INSTRUCTION TO SERVICE

ITS: 5694	
SECTION:	420 Body AP EXT
WRITTEN BY:	Kevin Robinson
SUBJECT:	Remove Wiper Relay Module

Figure 1: Wiper relay module as seen from the back of the driver's dash

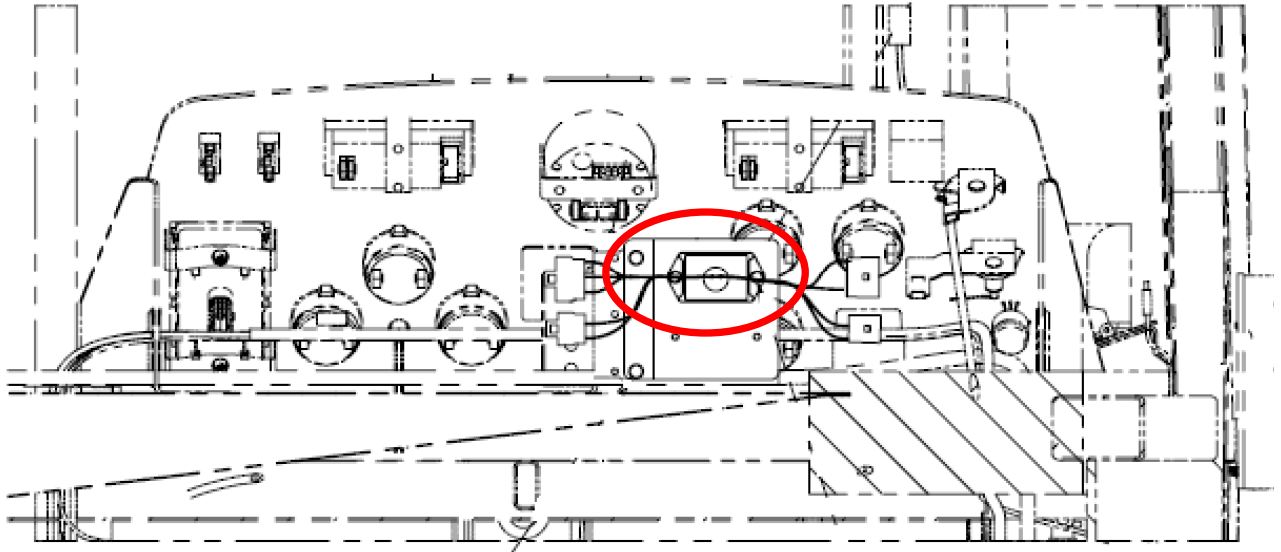
1. Turn the main battery disconnect switch to the “OFF” position.
2. Remove the dash panel.
3. Locate the wiper relay module. Refer to Figure 1.
4. Unplug the connectors from either side of the module.
5. Remove and discard the module, mounting bracket, and hardware.

6. Attach the two loose harnesses together and secure in place against vibration, etc.
7. Re-install the dash panel.
8. Turn the main battery disconnect switch to the “ON” position.
9. Run test to make sure wipers are working correctly. Repair as required.
10. Remove all tools and debris from the bus and return to service.
